**City of Kingston**  
**Report to Kingston Heritage Properties Committee**  
**Report Number HP-24-004**

**Subject:** Application for Heritage Permit

**Address:** 36 University Avenue (P18-338)

**File Number:** File Number: P18-073-2023

Fig. 1 Proposed replacement door design for French window at north Elevation.

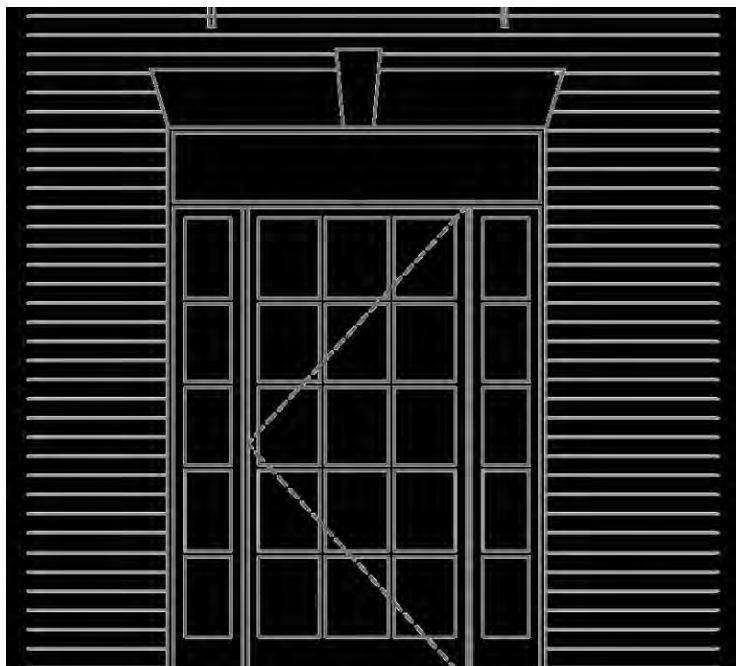
While the 2-by-5 French window at the north façade can be repaired, it does not meet requirements for an accessible door. Its existing geometry cannot provide the 965mm clear width required for new accessible doors by the Queen's Accessibility Standards (QAS), the 860mm clear width required by the QAS for retrofitted doors, or the 960mm required by the Ontario Building Code. Possible modifications were explored, but it cannot be appropriately modified while maintaining its original geometry. No other locations on the north facade were possible for the inclusion of a new accessible door and other interventions were not possible owing to the limited number of existing openings and Queen's programming requirements. Therefore, a new accessible door is being proposed in this location with a new design which will maintain the French window's geometry and attributes as closely as possible, in a style common among buildings of this style.

Exhibit C  
Report Number HP-24-004  
SP-A2.105

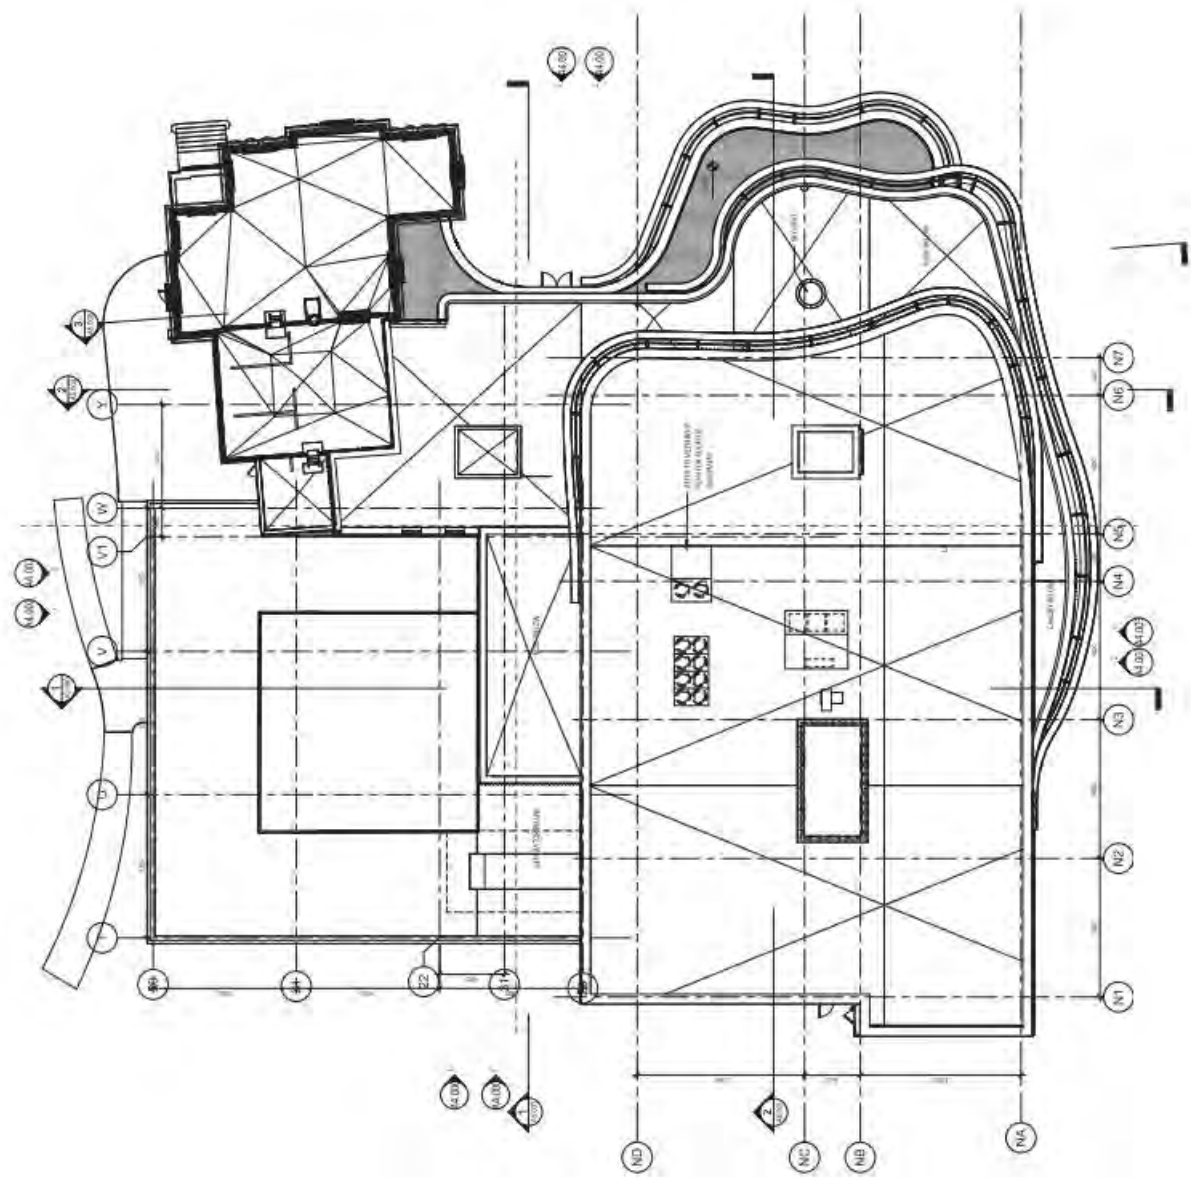
A new mechanical penthouse is also being introduced, and while it has been shown on the drawings submitted with the September 3 HIS, a revised SPA submission will reflect a new location. These details have been updated in a revised roof plan (A2.106) which is included on page 5 of this addendum.
